Model: PRIORT EMERALD/TOPAZ		Date: 3-Oct-06	No: M-C262-001
Modified Article: Parts catalog correction		Prepared by: M. Kumagai	
From: Priort Service Planning Section			
Classification:	☒ Parts catalog correction ☐ Vendor change ☐ To meet standards ☐ To facilitate assembly ☐ To improve reliability () ☐ Part standardization ☐ Other ()		
Model Name: EMERALD: Ricoh HQ9000, Gestetner CP6346, RexRotary CP6346, nashuatec CP6346, Savin 3590DNP, Standard SD700, Lanier LDD280 TOPAZ: Ricoh HQ7000, Gestetner CP6334, RexRotary CP6334, nashuatec CP6334, Savin 3580DNP, Standard SD460, Lanier LDD250

Model: PRIPORT EMERALD/TOPAZ		Date: 16-May-07	No: M-C262-002
Modified Article: Change of the shapes of the two Plotter slide rails.		Prepared by:	
From: Priport Service Planning Section		M. Kumagai	
Classification: ☐ Parts catalog correction ☐ Vendor change ☐ To meet standards ☐ To facilitate assembly ☒ To improve reliability () ☐ Part standardization ☐ Other ()			
Model Name: EMERALD: Ricoh HQ9000, Gestetner CP6346, RexRotary CP6346, nashuatec CP6346, Savin 3590DNP, Standard SD700, Lanier LDD280 TOPAZ: Ricoh HQ7000, Gestetner CP6334, RexRotary CP6334, nashuatec CP6334, Savin 3580DNP, Standard SD460,

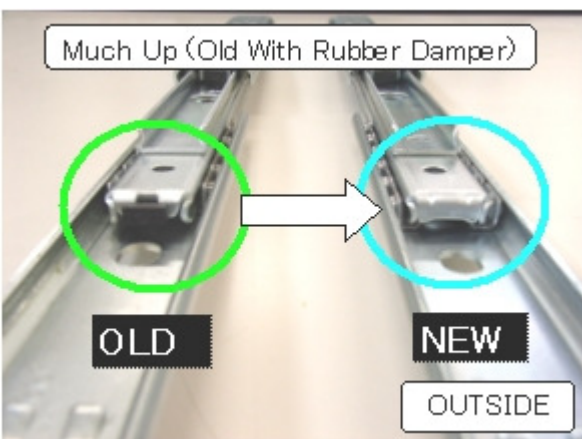
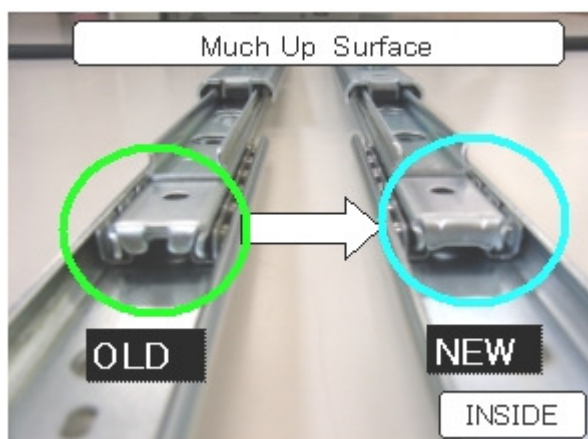
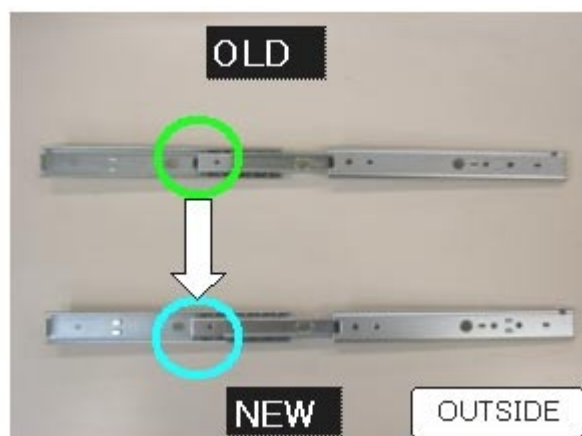
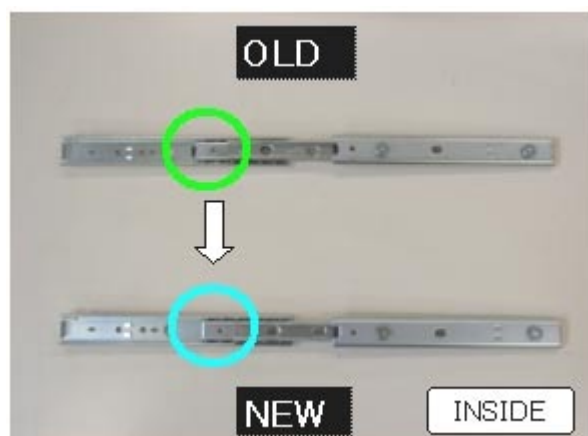
Change: The material of the plotter side rails was changed, and the rubber dampers were removed.

Reason: Sometimes, the rubber damper came loose from the side rail.

Old #	New #	Description	Qty	Int	Page	Index	Note
C2442275	C2622280	SLIDE RAIL:PLOTTER	2	X/O	9	20

38.Master Eject 2 (C262/C265)

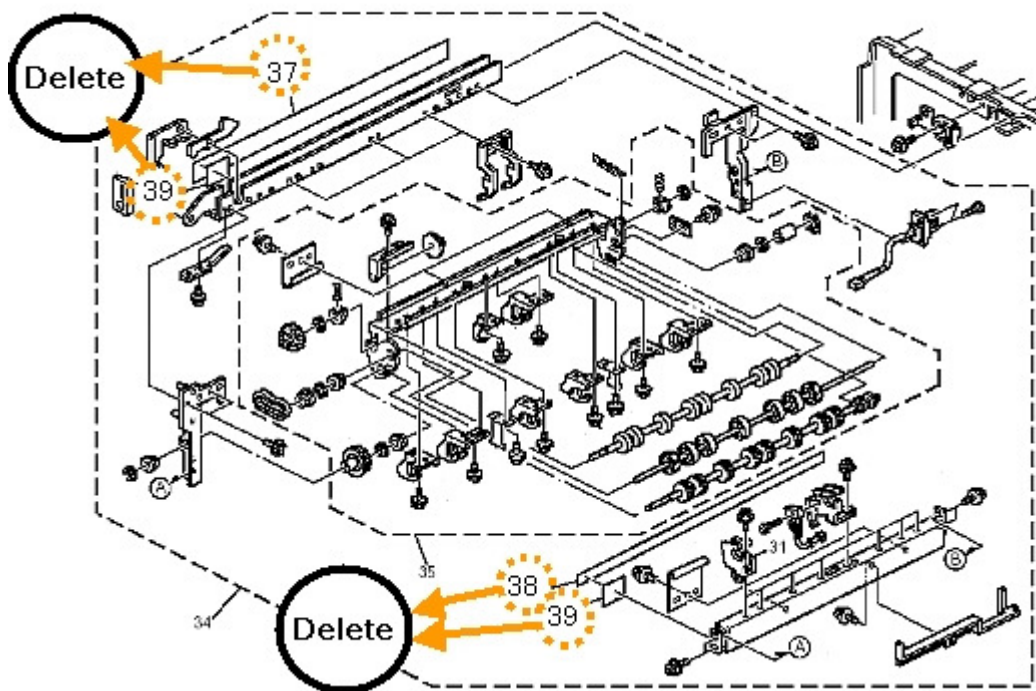
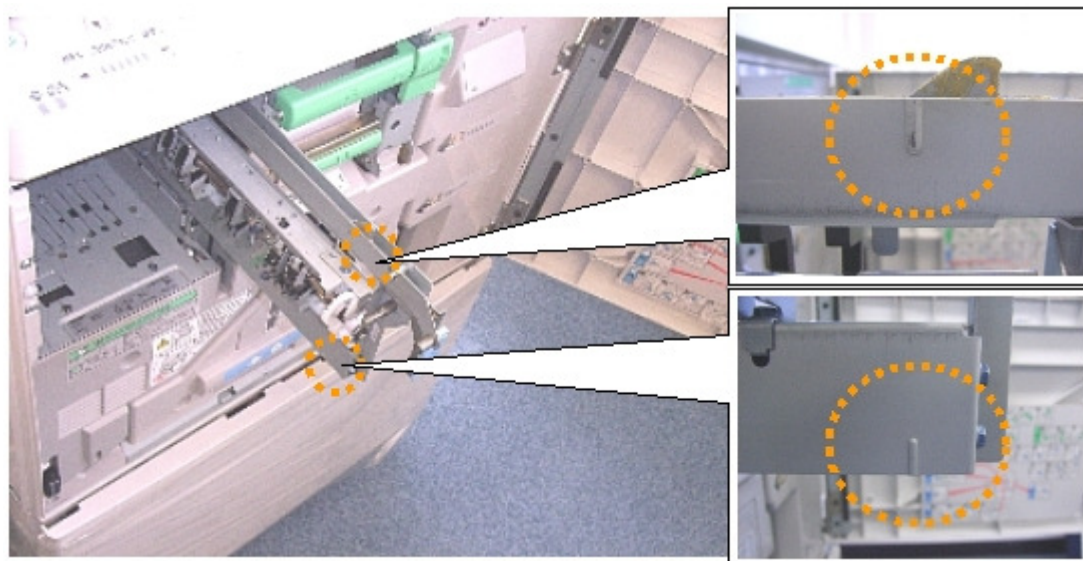
- 1) The Mylar shown below was deleted.
- 2) Small projections were added to the upper and lower master eject roller stays.

Reason: To facilitate assembly.

Old #	New #	Description	Qty	Int	Page	Index
C2443485	C2593485	Side Rail:Upper:Peen	1	X/X as a set	77	12
C2443464	C2593464	Stay:Lower:Side Plate:Moveable	1	X/X as a set	77	32
C2573400	C2653400	Transport Unit	1	X/O	77	34

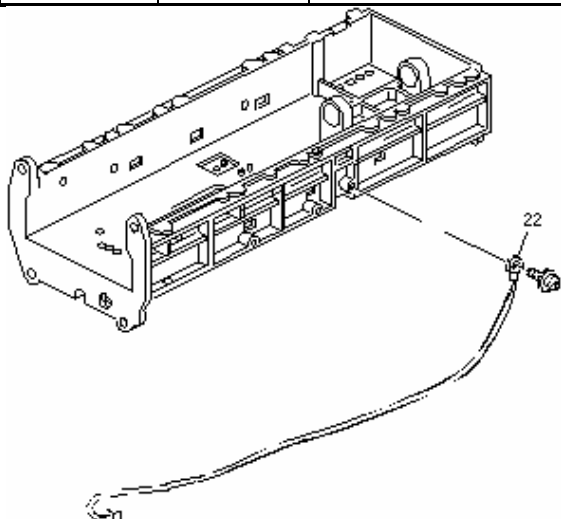
Change: The length of the cover tube for the thermistor was increased from 140mm to 230mm.

Reason: To better protect the thermistor.

Old #	New #	Description	Qty	Int	Page	Index
C2575861	C2575865	THERMISTOR:ASS'Y	1	X/O	53	22

38.Master Eject 2 (C262/C265)

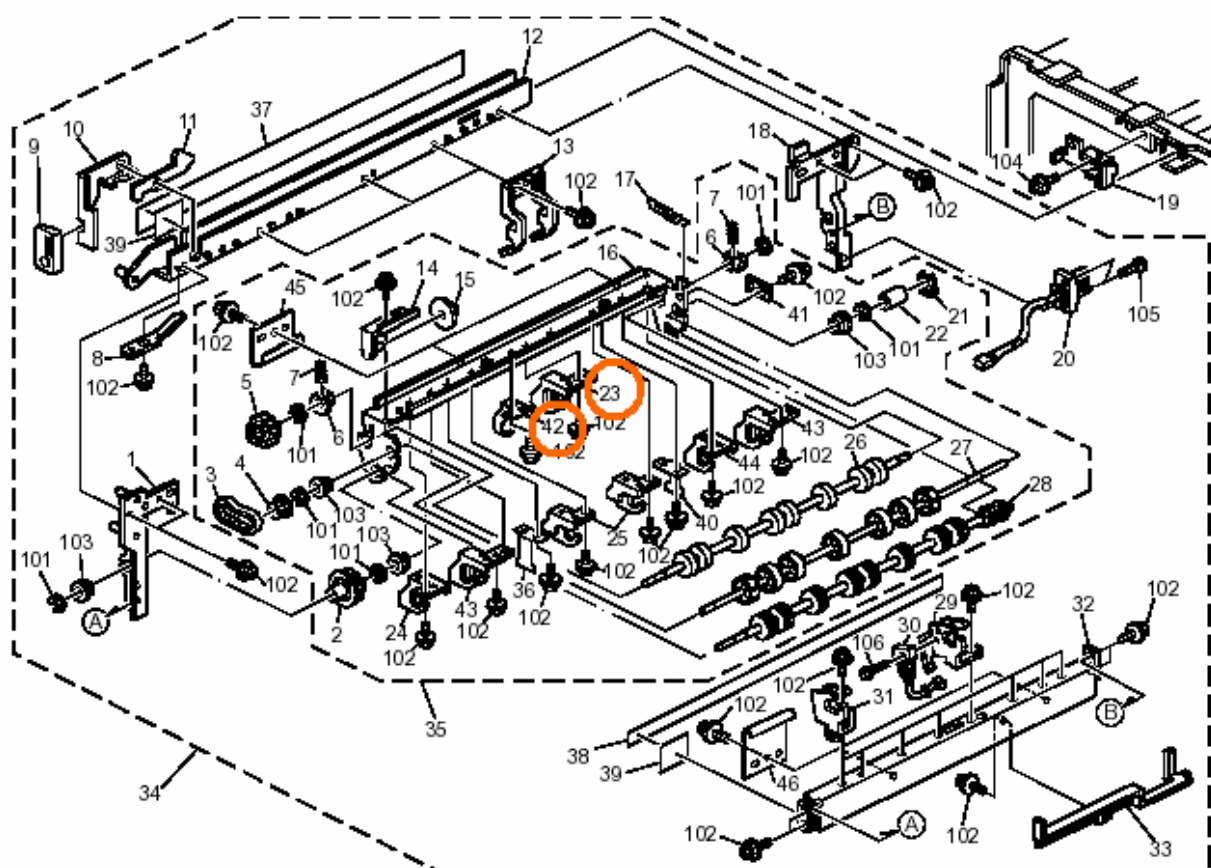
Change: The shape of the master eject sensor bracket was changed (parts standardization with the Cat's eye (C269)).

Reason: To improve the detection accuracy of the master eject jam sensor.

Important: When you attach either part for the first time, install both parts **together as a set**.

Old #	New #	Description	Qty	Int	Page	Index
C2443455	C2653455	Guide : Upper Rear	1	X/O	77	23
C2573458	C2653458	Guide	1	As a set	77	42

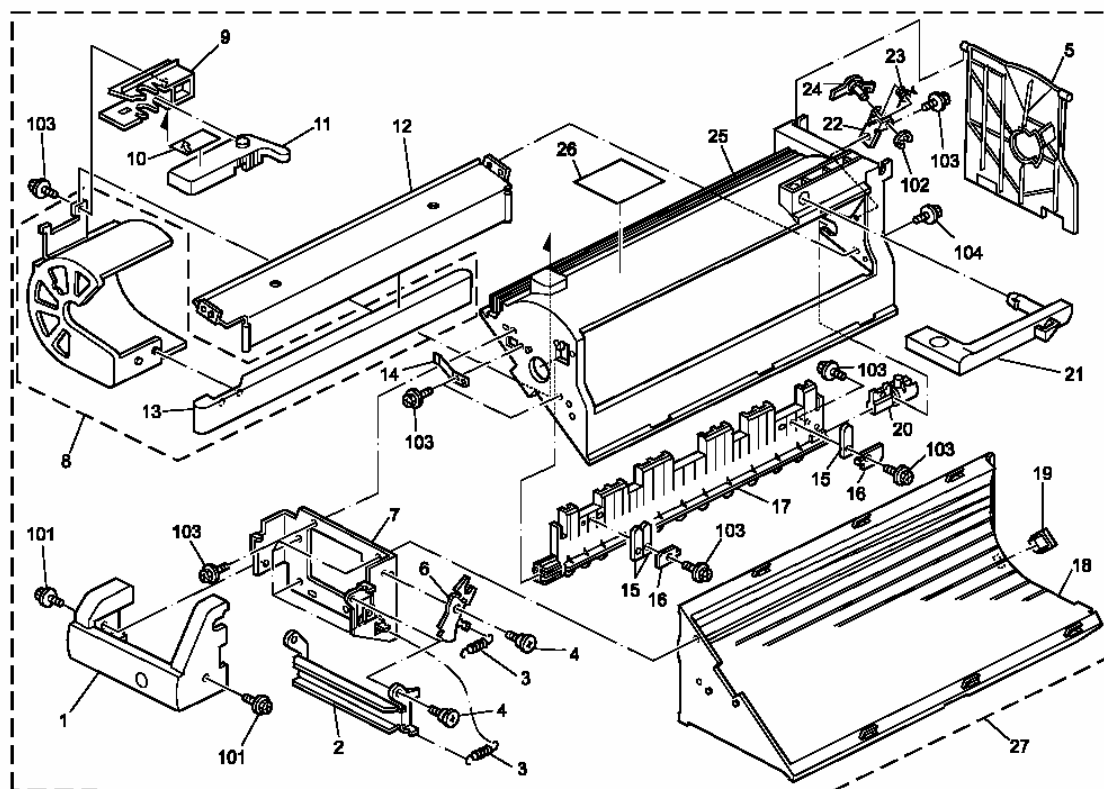
Change: The shapes of the component parts of the Master Eject Box were changed (the measurement specifications were made stricter).

Reason: To ensure that the parts do not bump each other when ejected masters are ejected from the master eject box.

Old #	New #	Description	Qty	Int	Page	Index
C2443402	C2653407	Case:Master Ejection:Ass'y	1	X/O	79	27

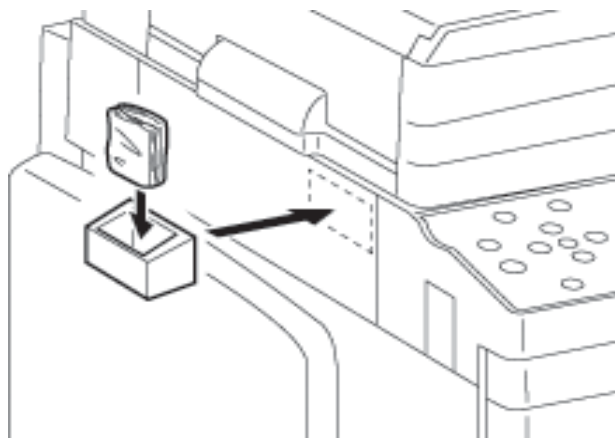
Change/Reason: The parts in the table were added as service parts (they are already contained in the Accessories Bag).

Important: Attach the cloth holder at machine installation.

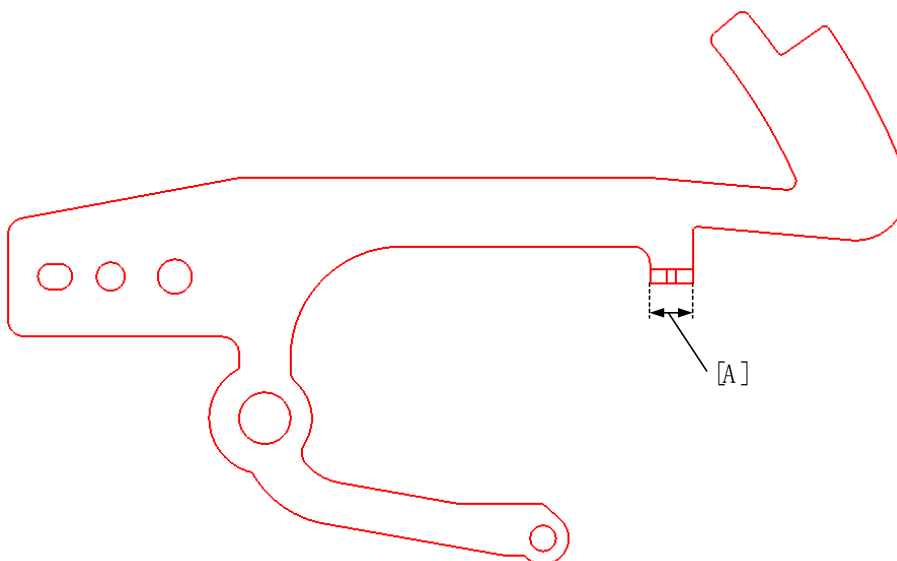
Change: The width [A] at the feeler of the paper height sensor was decreased, from 7.0mm to 5.0mm.

Reason: SC521 (Paper table lock, paper table height sensor) occurs when the feeler gets caught and prevents the feeler from lowering (the paper table height sensor cannot de-actuate).

[A]: 7.0mm → 5.0mm

Old #	New #	Description	Qty	Int	Page	Index
C2572862	C2652862	FEELER:PAPER FEED ROLLER	1	X/O	27	23

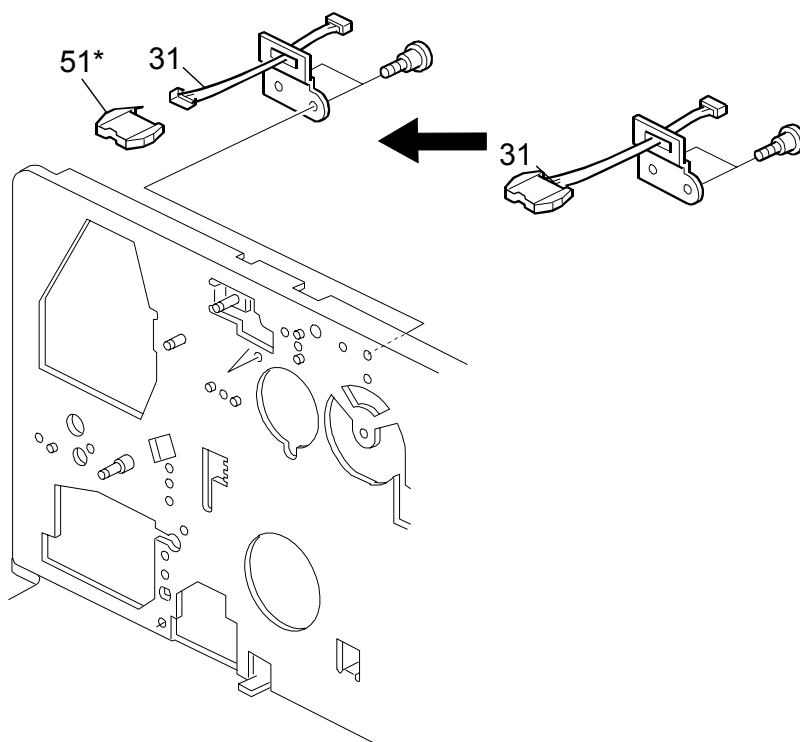
Change/Reason: This part was missing from the Parts Catalog.

P/N	Description	Qty	Page	Index
11029860	CONNECTOR:DRAWER:04P-RIZ-K2GG-RL(LF)	1	39	51*

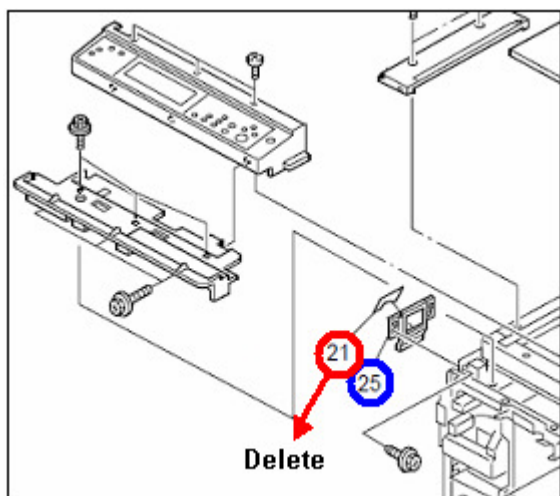
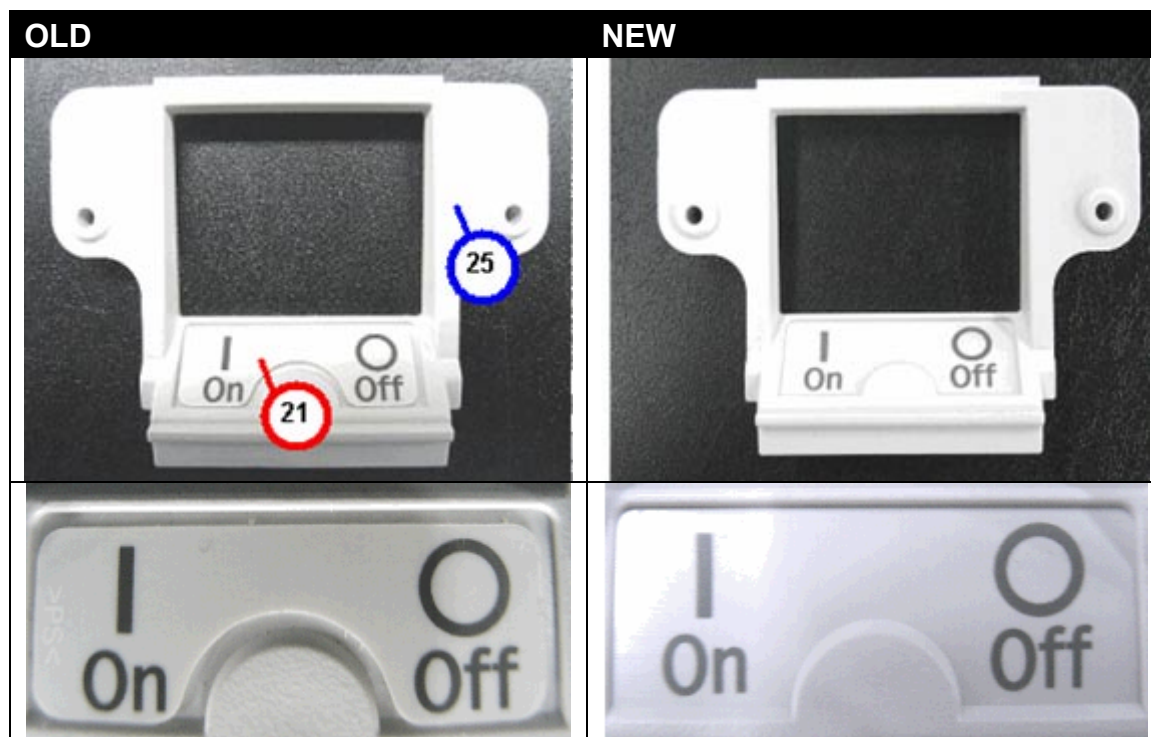
Change: The decal on the main switch cover was deleted.

Reason: The content of the decal is now printed directly onto the main switch cover itself.

Old #	New #	Description	Qty	Int	Page	Index
C2621370	C2691369	Cover: Main Switch	1	X/O	5	25
C2621373		Decal: Main Switch	0		5	21

42.Electrical Section 1 (C262/C265)

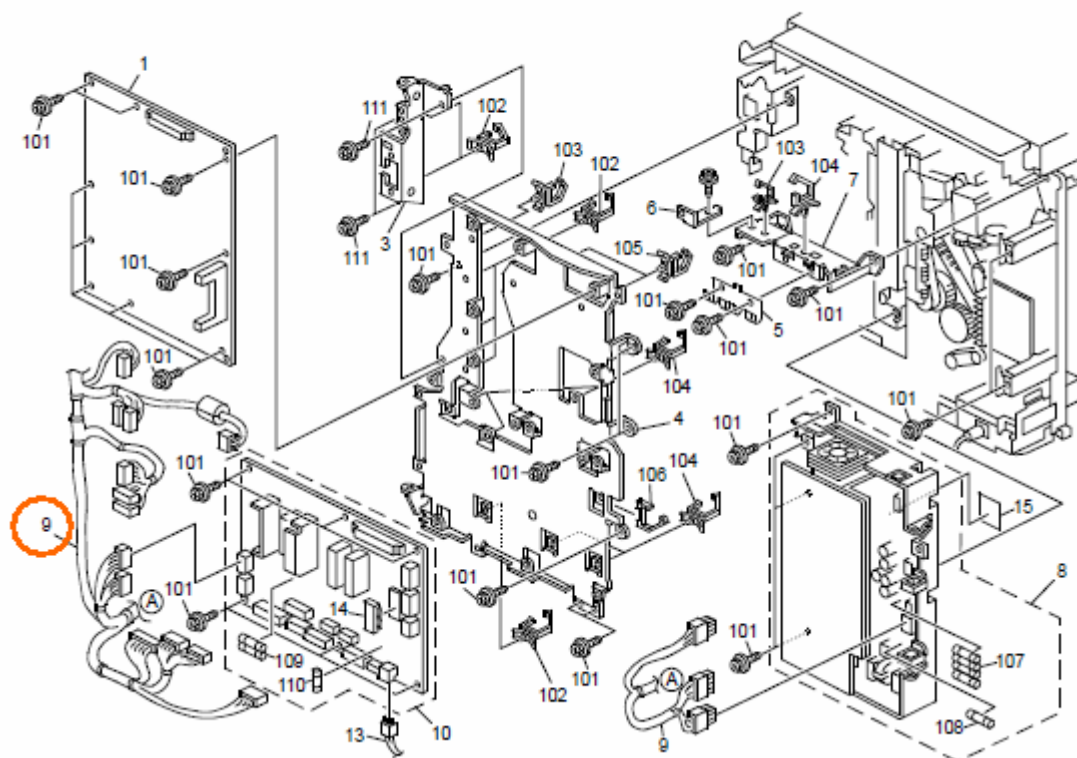
Change: The material of the main harness was changed (strengthened).

Reason: To improve the durability of the harness.

Old #	New #	Description	Qty	Int	Page	Index
C2625280	C2625270	Harness DC drive Ass'y	1	O/O	85	9

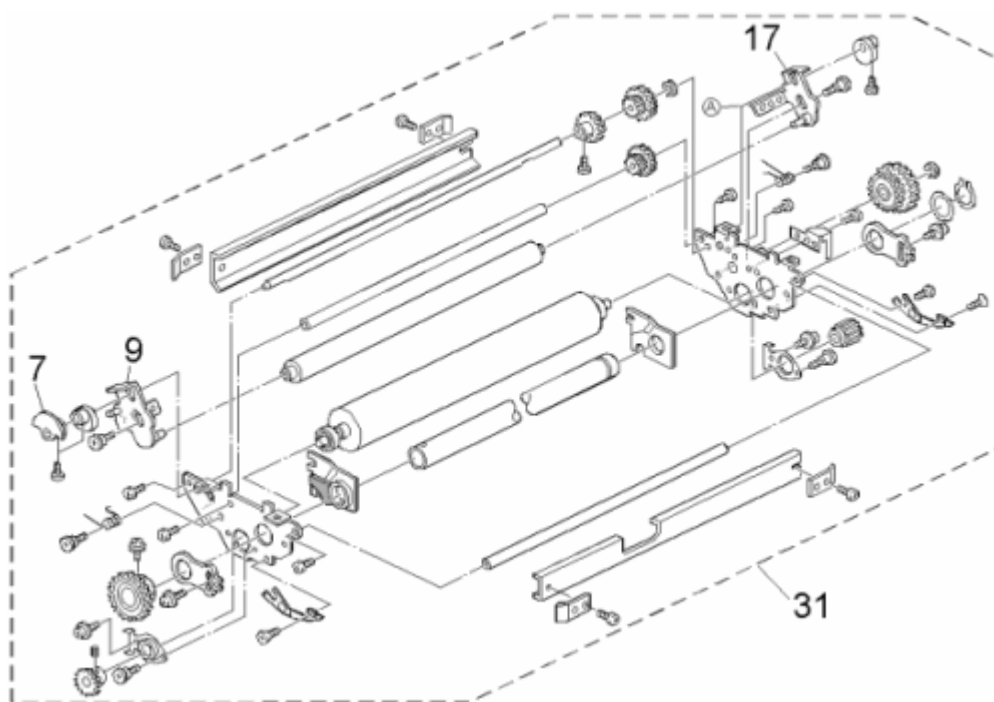
Change: The shape of the actuator disk for the idling HP sensor was changed.

Reason: To further ensure that ink does not leak or stick to the inside of the drum.

Index 7: C262551

Index 9: 2622570

Index 17: C2622573

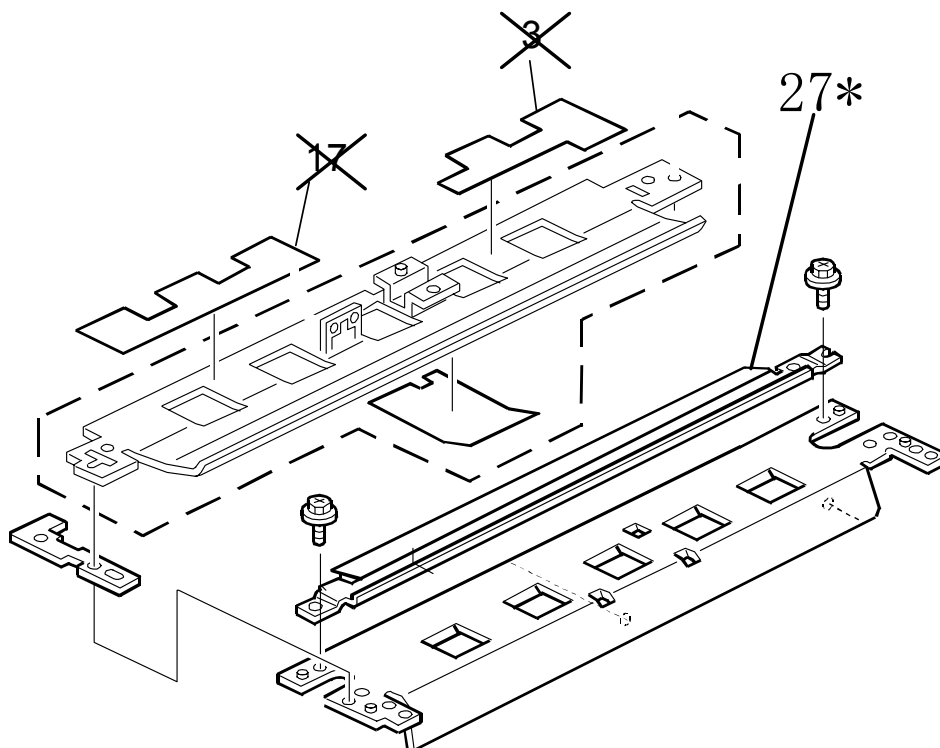
Change: Two Mylars were deleted and a paper feed guide plate was added.

Reason: To improve feeding of No. 10 envelopes.

Old #	New #	Description	Qty	Int	Page	Index
C2572929	-	Plate Guide – short	1	X/O	33	3
C2572928	-	Plate Guide – long	1	as a	33	17
-	C2362927	Paper Feed Guide Plate Ass'y	1	set	33	27*

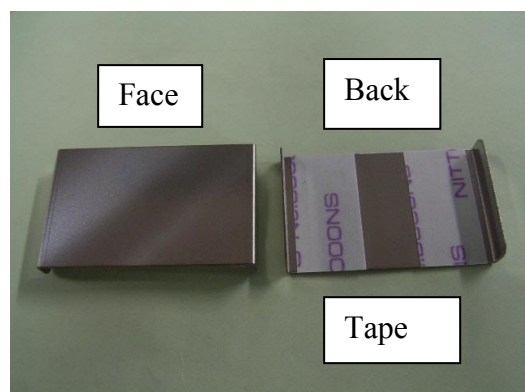
Change: Covers for the master eject rollers were added.

Reason: To ensure the ejected master moves more smoothly along the master eject roller.

Old part number	New part number	Description	Q'ty	Int	Page	Index	Note
-	C2653620	Guide: Master Ejection: Adhesion	2	-	77	*47	New index
